ADDENDUM

Reference: UVU Retention
DFCM Project No. 07355790

Subject: **Addendum No. 2**

C-107

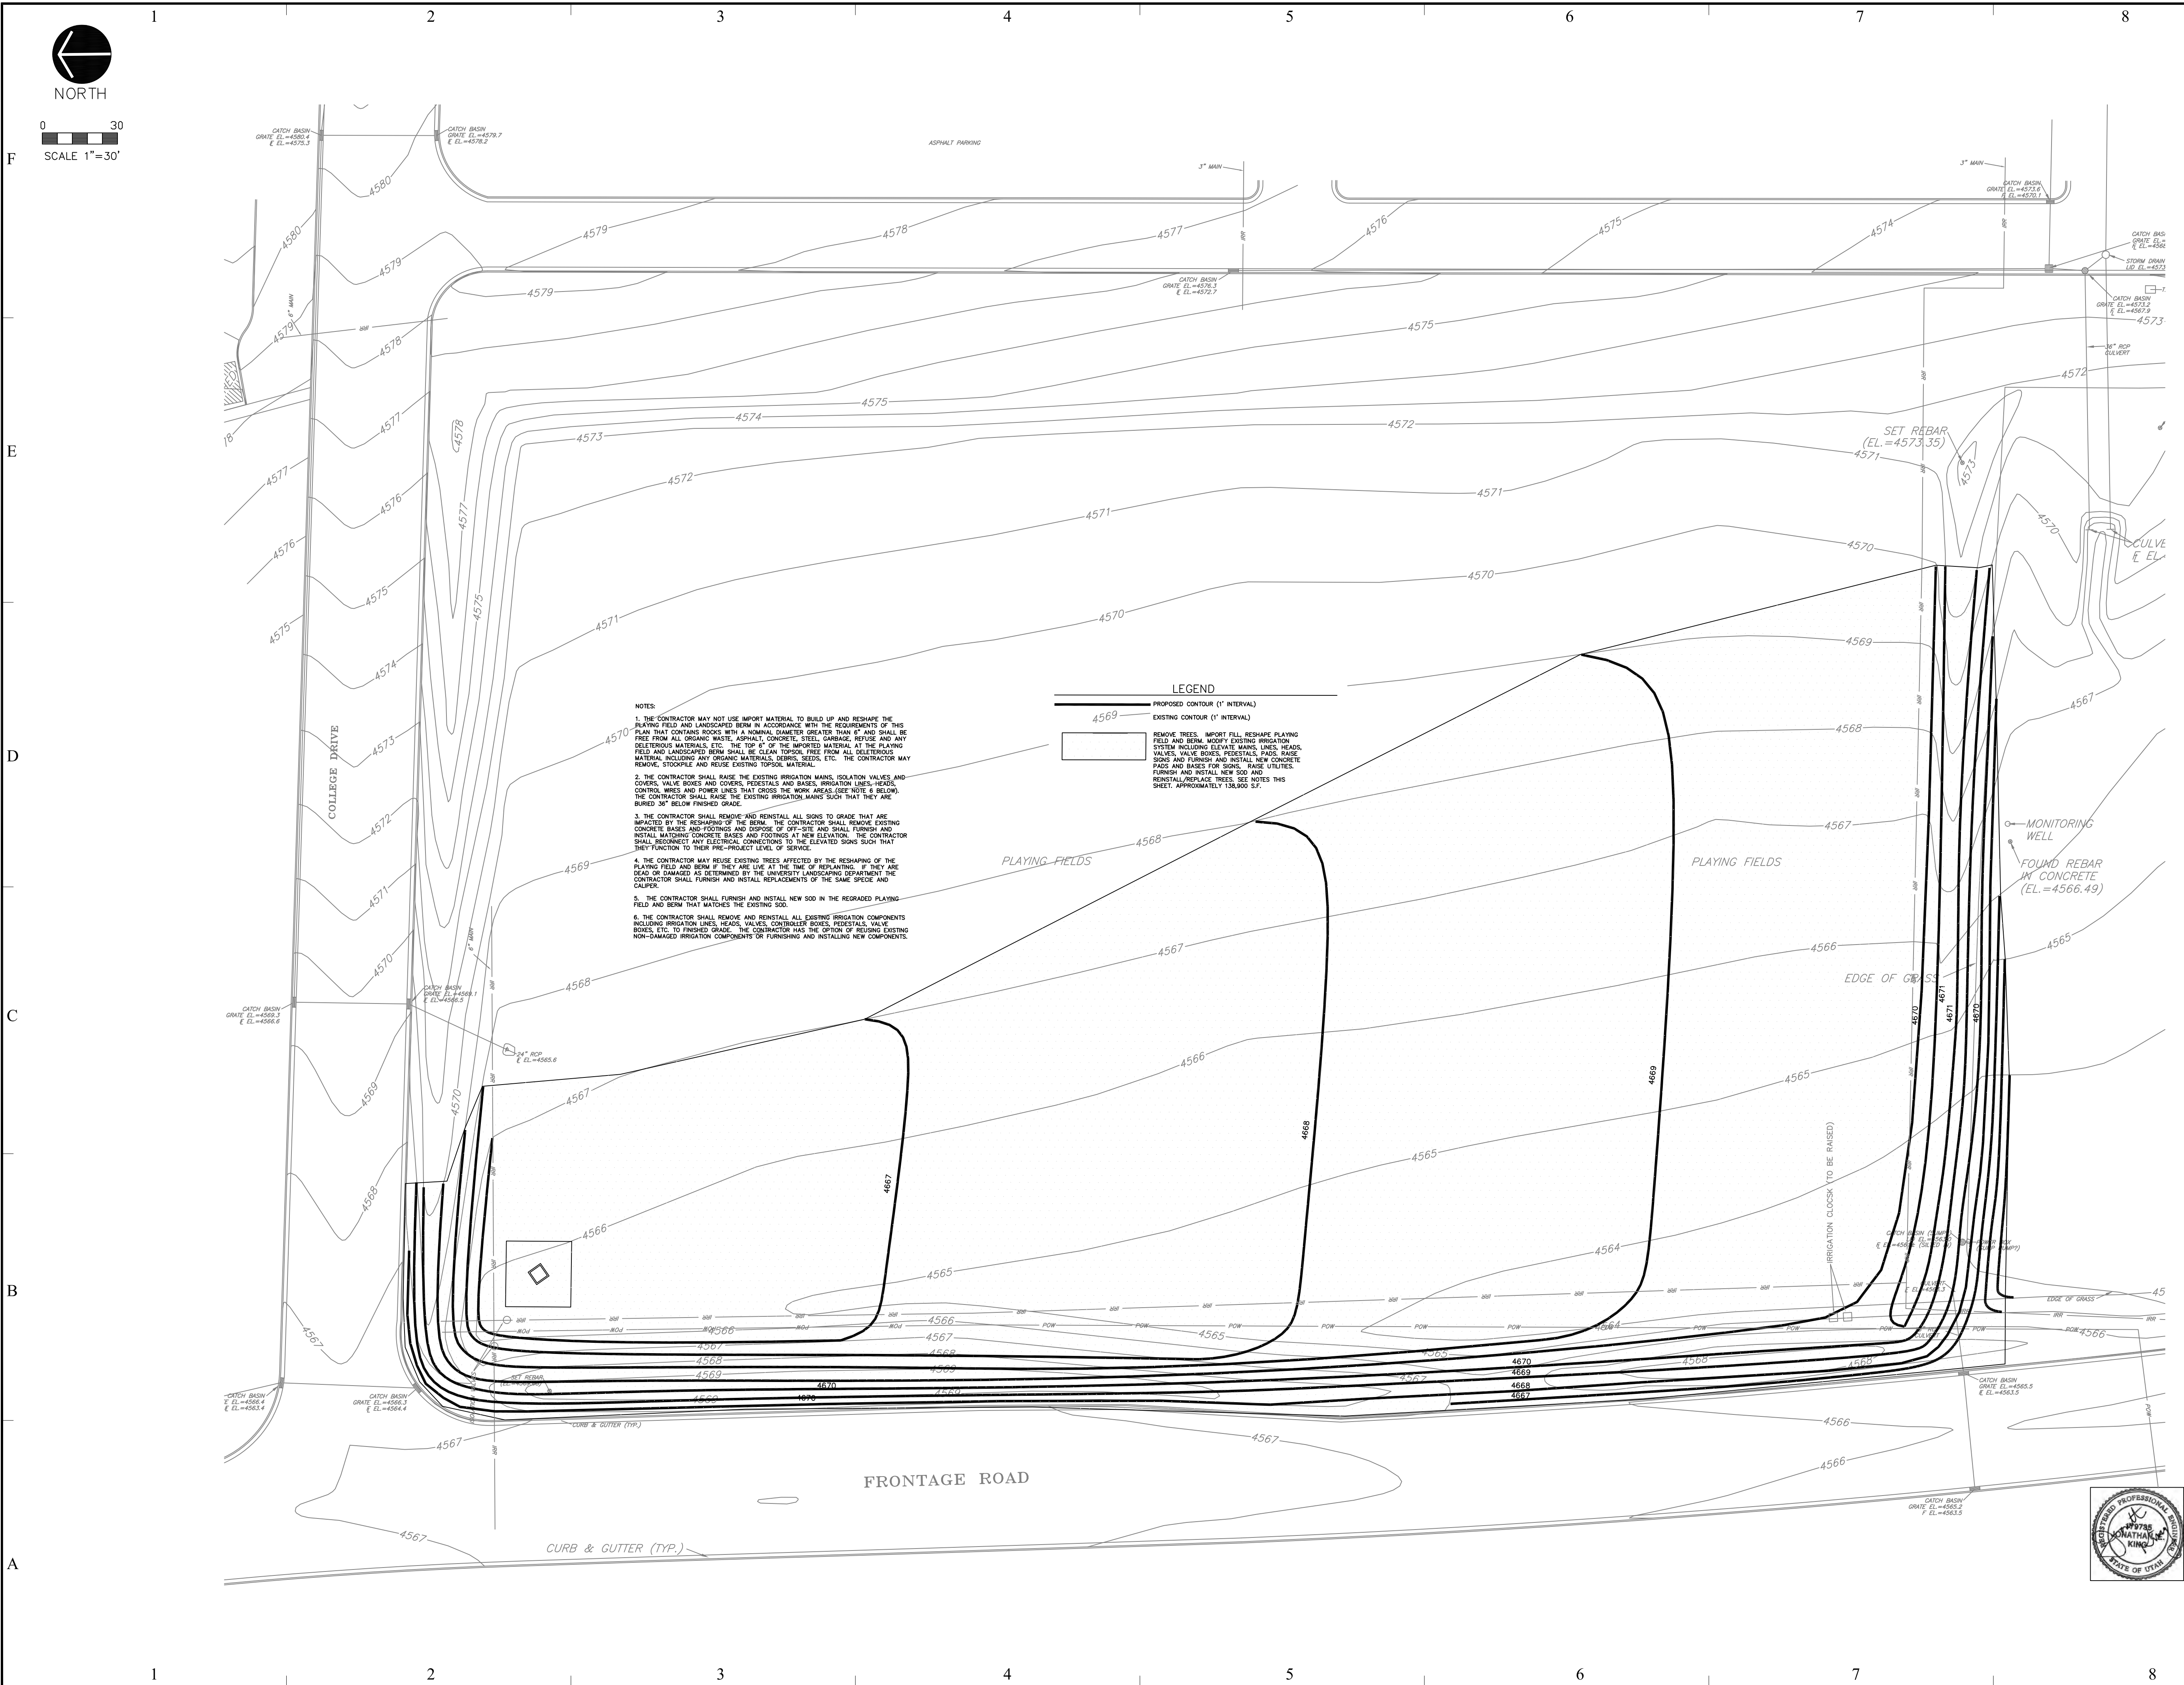
3. The attached grading plan sheet C-107 is a supplemental grading plan that shall replace existing grading plan sheets C-105 and C-106 of the Bid Set. Sheet C-107 shall be plotted to scale of 1"=30' at a 24" x 36" size. Sheet C-107 shows updated grading and notes pertaining to the construction of the retention basin and reshaping of the berm.
